**REMEDIAL INVESTIGATION/FEASIBILITY STUDY (RI/FS) DESCRIPTION
OF CURRENT SITUATION - (RESPONSES TO EPAs' COMMENTS AND
CHANGE PAGES)**

REMEDIAL INVESTIGATION/FEASIBILITY STUDY (RI/FS) DESCRIPTION OF CURRENT SITUATION

**REMEDIAL INVESTIGATION
AND
FEASIBILITY STUDY,
FEED MATERIALS PRODUCTION CENTER
Fernald, Ohio**

FIGURE 2.2
 FEED MATERIALS PRODUCTION CENTER SITE, FERNALD, OHIO

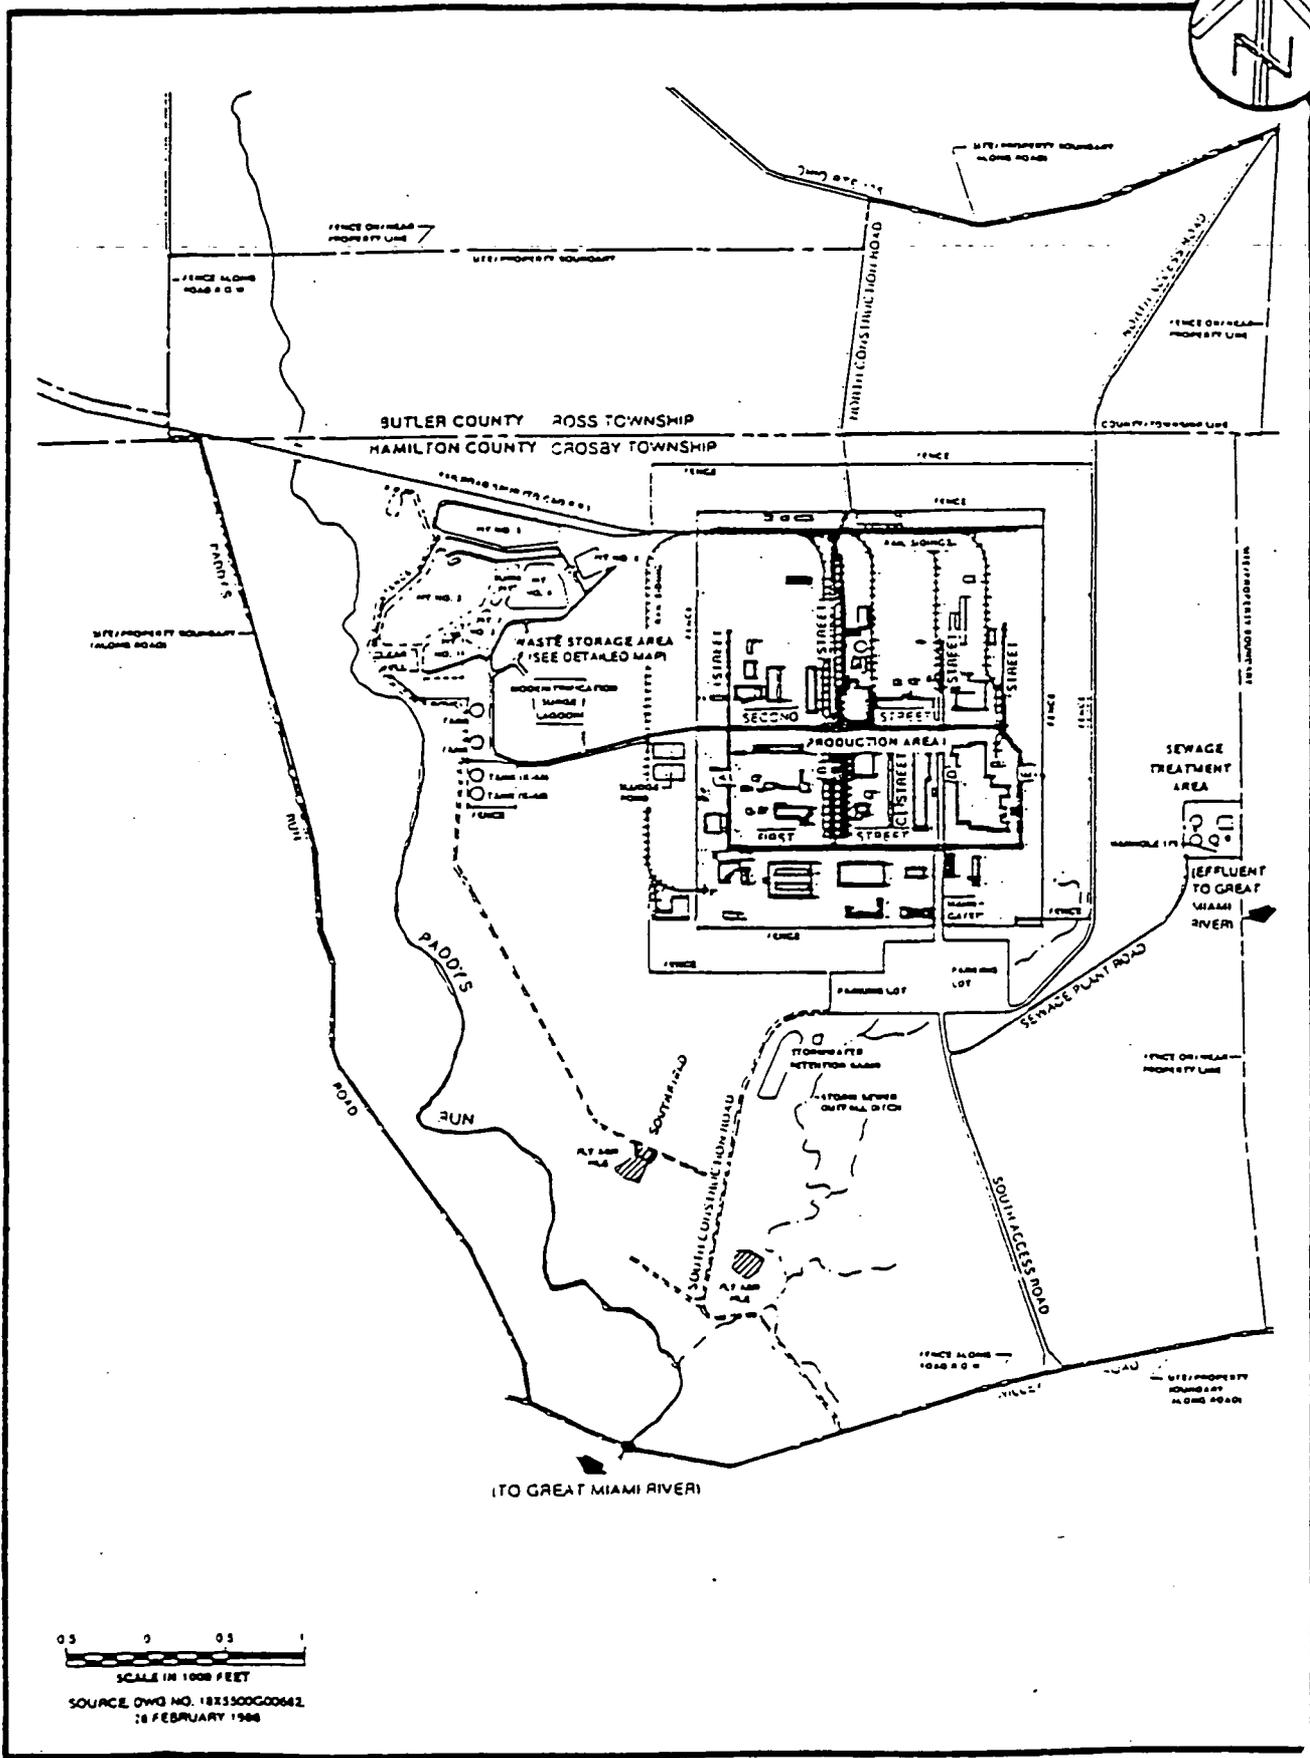
SECTION/FIGURE: Section 3.6 **PAGE:** 3-27
Mentions the location of the Southfield area, however it is not identified in Figure 2.2. This site should be shown in Figure 2.2.

The location of the Southfield area will be shown on a revised site map, Figure 2.2

The above response will be incorporated into Figure 2.2 of the Task 1 Report: Description of Current Situation.

PROPOSED: (Replace with the attached Figure 2.2)

Figure 3.6 FMPC Waste Treatment Flow Diagram

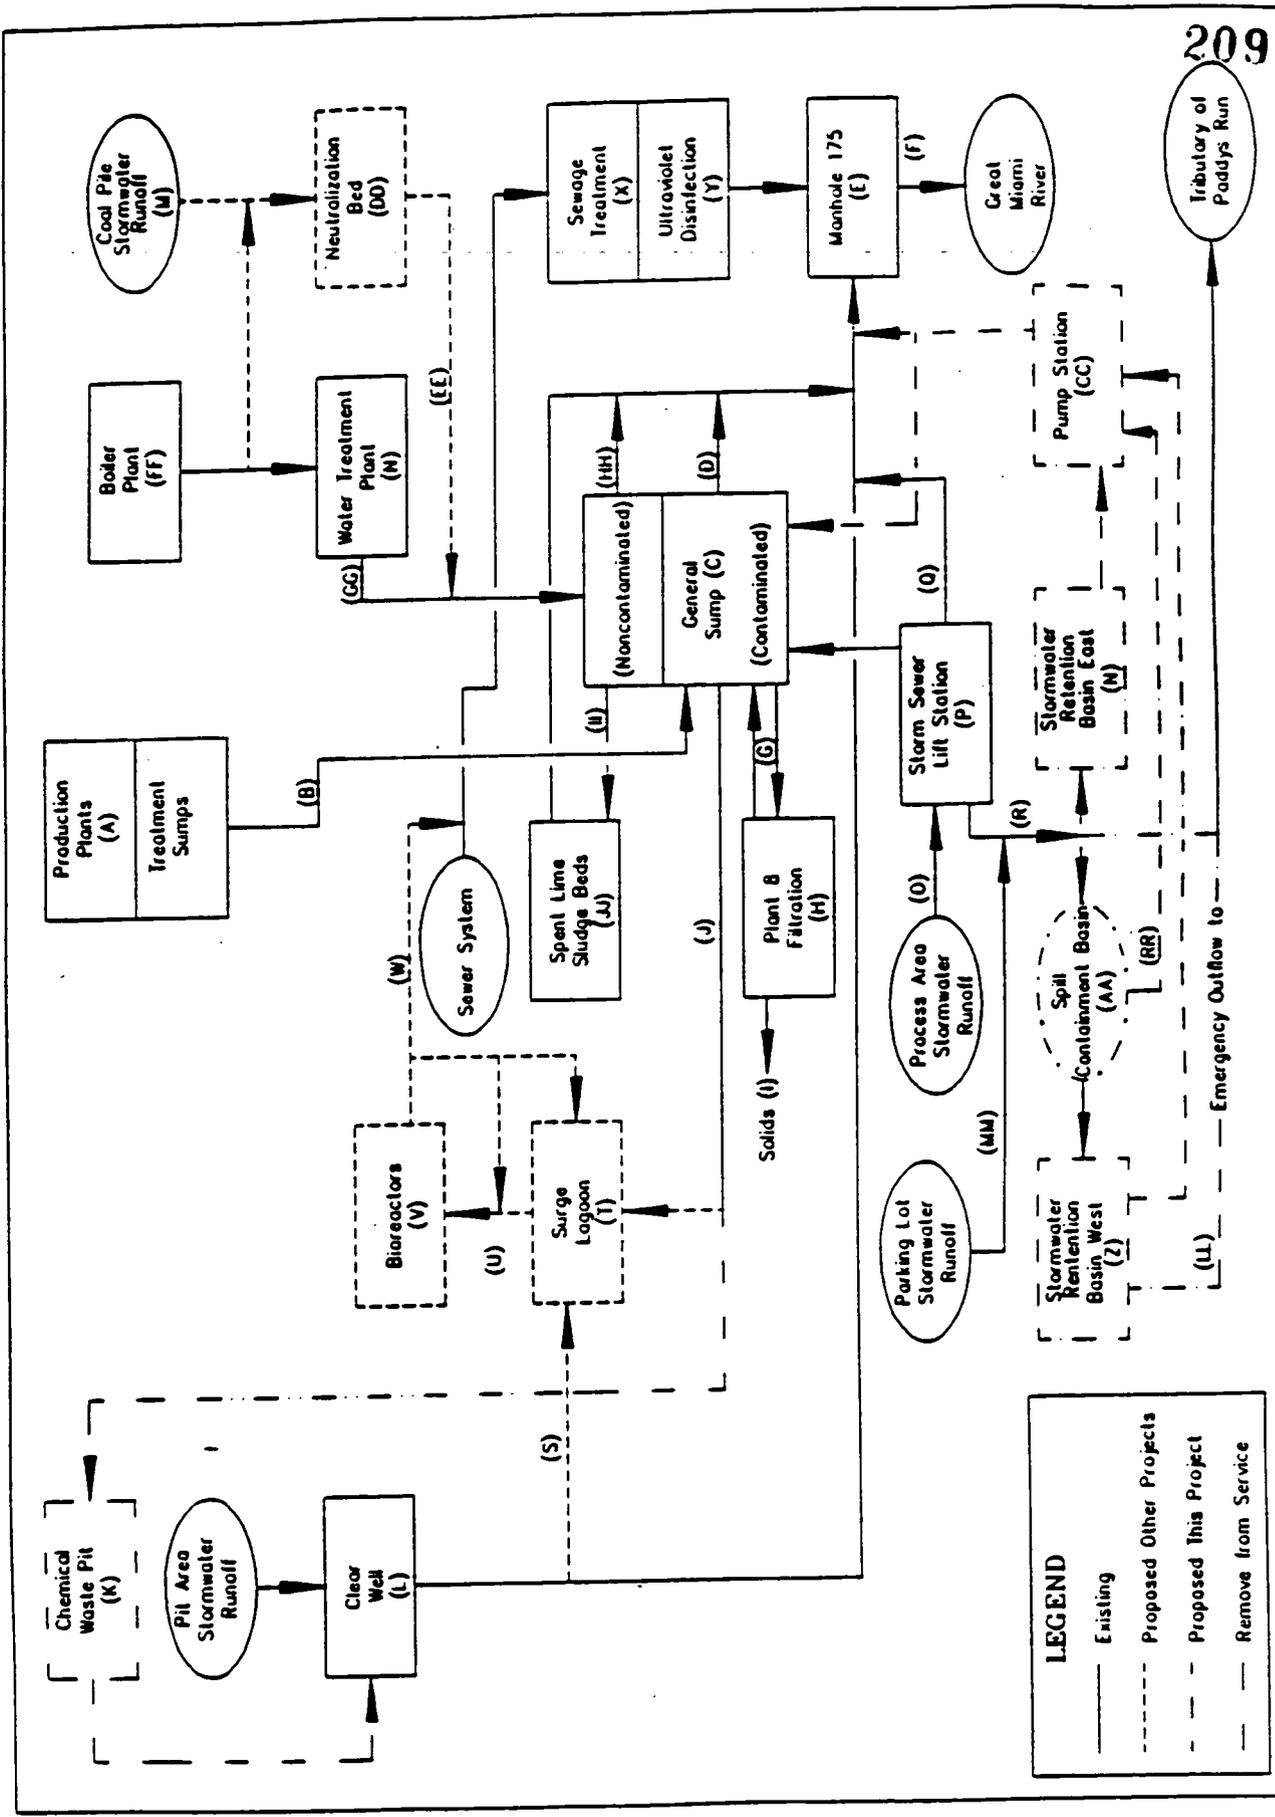
As of February, 1987, the Clear Well no longer received process discharges, only Waste Pit runoff. Sections 3.4.1, 3.4.2, and 3.4.3, Figures 3.5 and 3.6, and Section 5.2.6 of the Task 1 Report: Description of Current Situation will be changed to reflect the change of status of the Clear Well.

PROPOSED: (Replace with the attached Figure 3.6)

FIGURE 3.8
 GROUND WATER MONITORING WELL LOCATIONS

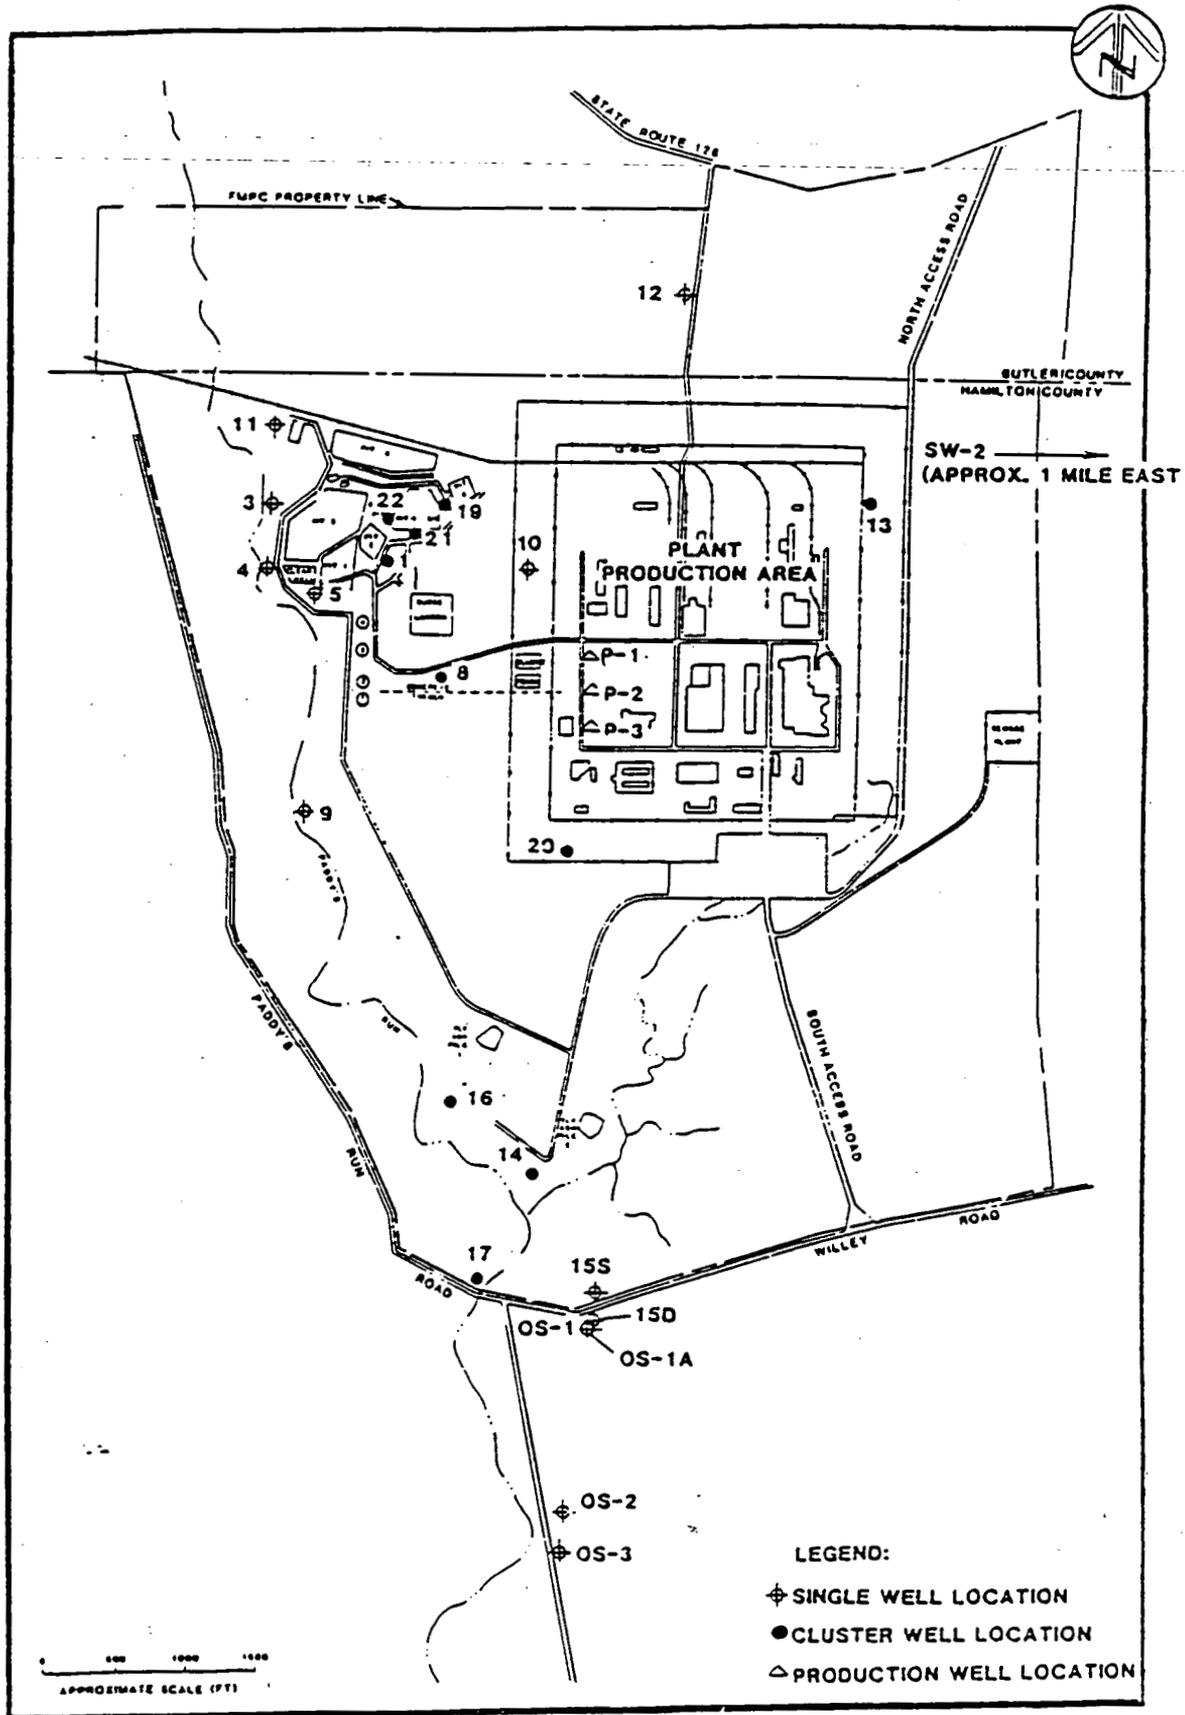
SECTION/FIGURE: Figure 3.8 PAGE: 3-67
Displays that no ground water monitoring wells are located to the southeast of the FMPC and only one is located to the east. Additional wells in both areas are recommended.

SECTION/FIGURE: Section 3.8.2.2 **PAGE:** 3-69
Discusses the 41 site monitoring wells. A site map should be included to clarify which "off-site" and "on-site" wells will make up the 41 well monitoring system.

SECTION/FIGURE: Table 3.18 PAGE: 3-72
Sampling points T1S, 1D are not shown in Figure 3.8. Why are the results of the remaining wells shown in Figure 3.8 not listed in Table 3.18. Footnote "b" does not make any sense.

The Ground Water Sampling Plan (including applicable change pages resulting from U. S. EPA comments), submitted as part of Volume I: Sampling Plan and the revised Work Plan define the proposed monitoring well network proposed under the RI. The proposed monitoring network addresses this concern.

The 41 wells are identified in Figure 3.8. There are 35 on-site wells and 6 off-site wells.

labeled on Figure 3.8 (just east of pit 2). This will be corrected. The wells listed in Table 3.18 were sampled as part of the Environmental Monitoring program. The remaining wells shown on Figure 3.8 are part of the RCRA compliance program. These results have been supplied in Task 1 through 4 of the RCRA program, and submitted in 1986-1987. Footnote "b" should read "Concentration in air and water above natural background."

The above response will be incorporated into Table 3.18 and Figure 3.8 of the Task 1 Report: Description of Current Situation.

PROPOSED: (Replace with the attached Figure 3.8)

FIGURE 3.10 Air Monitoring Station Locations

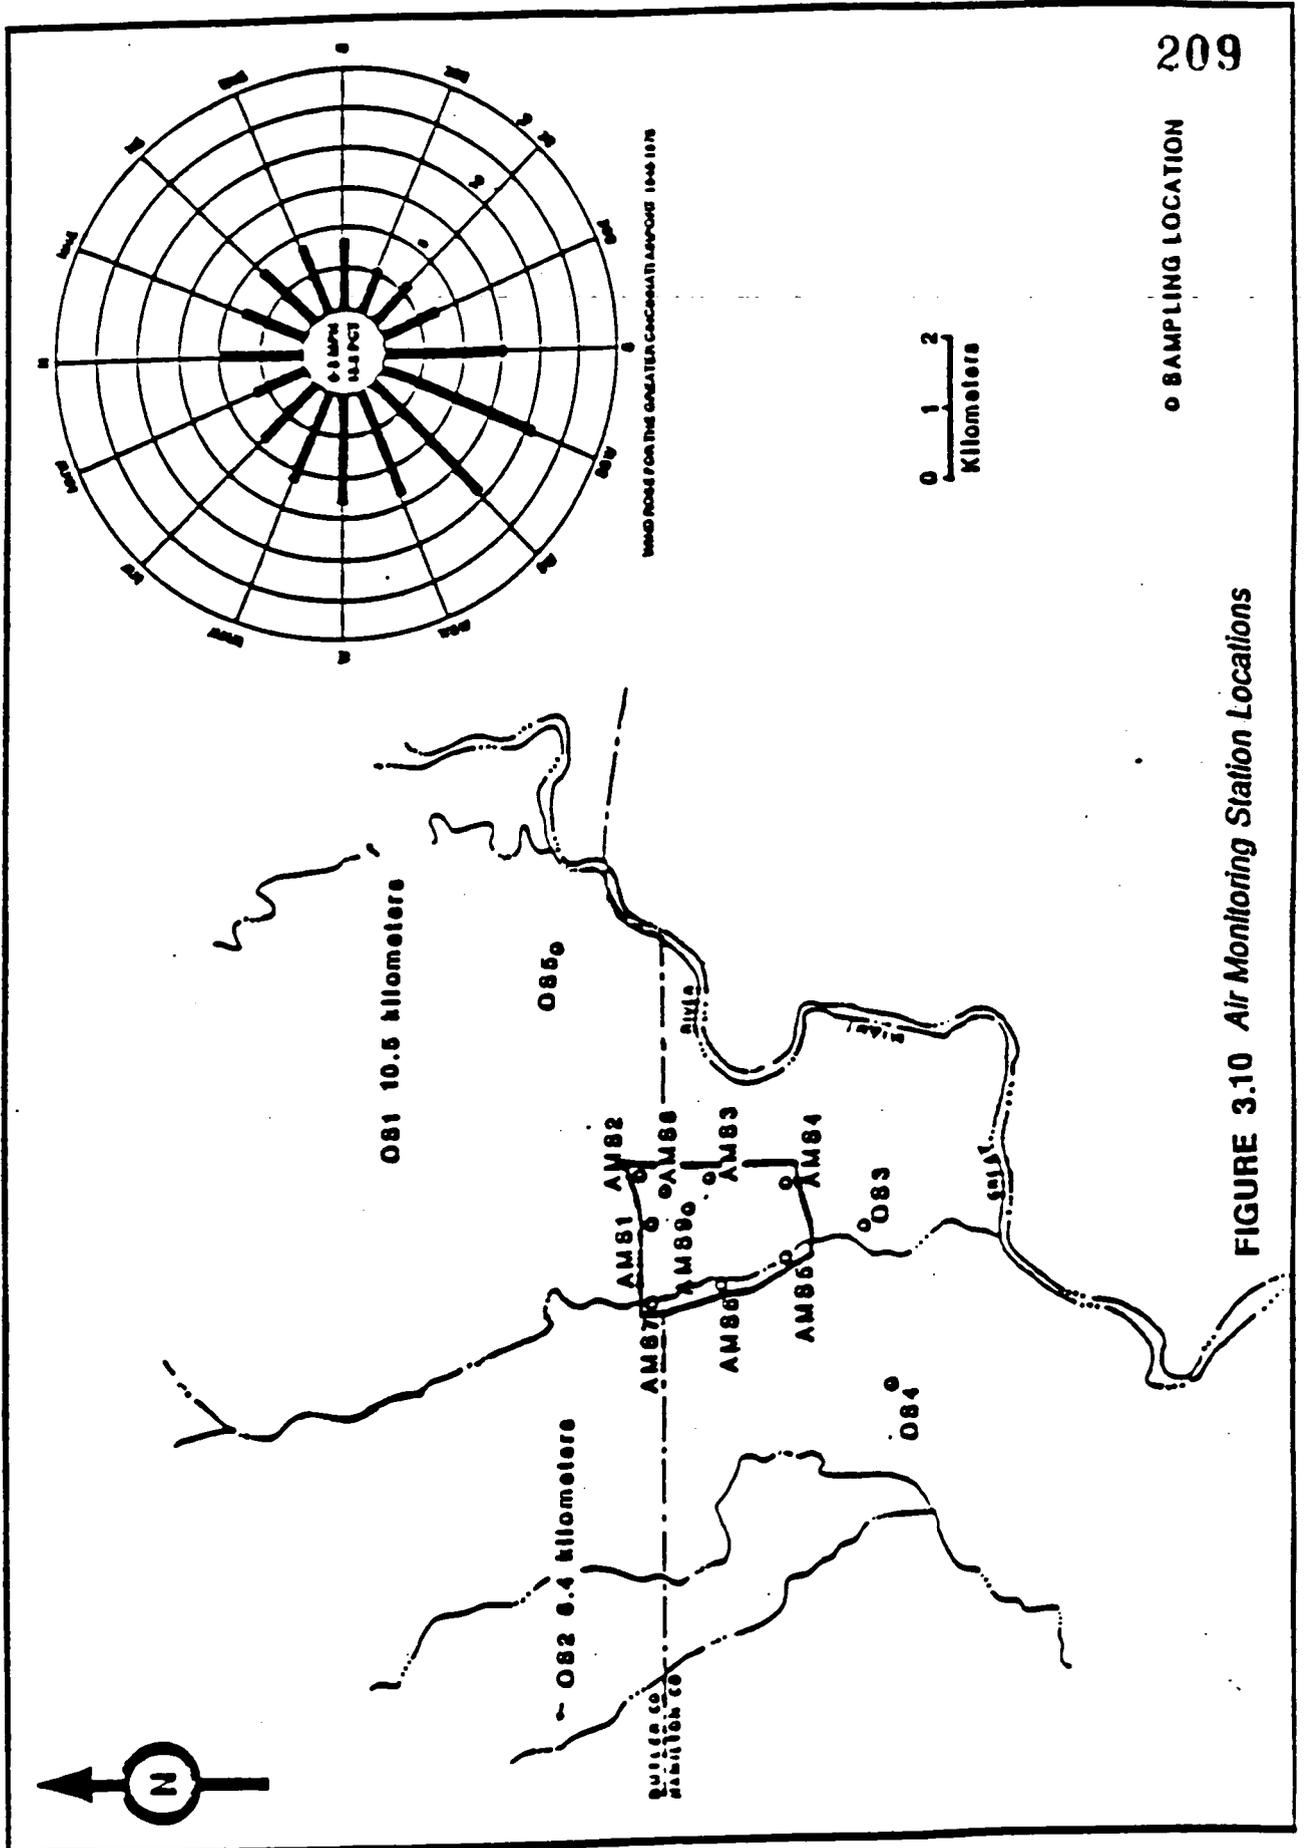
SECTION/FIGURE: Section 3.8.3.1 **PAGE:** 3-76
Should identify by name or site symbol the existing and new air monitoring sites.

SECTION/FIGURE: Section 3.8.3.2 **PAGE:** 3-85
Must clarify if locations 1-9 are also known as locations BS1 - BS9. In addition, the designations for air monitoring sites in Table 3.22 and in this section do not agree with those on Figure 3.10.

The nine on-site air monitoring stations and the five off-site air monitoring stations are shown in the new Figure 3.10. The five existing off-site monitoring sites are identified in Figure 3.10 as the OS1 through OS5.

The above response will be incorporated into Section 3.8.3.1, and Figures 3.10 of the Task 1 Report: Description of Current Situation. Figure 3.11 will be deleted from the text.

PROPOSED: Continuous air sampling is carried out at nine locations on or near the plant boundary as shown in Figure 3.10. There are also five additional off-site monitoring stations located to the south, south-west, west, north-east, and east, as shown on Figure 3.10.

PROPOSED: (Replace with the attached Figure 3.10)
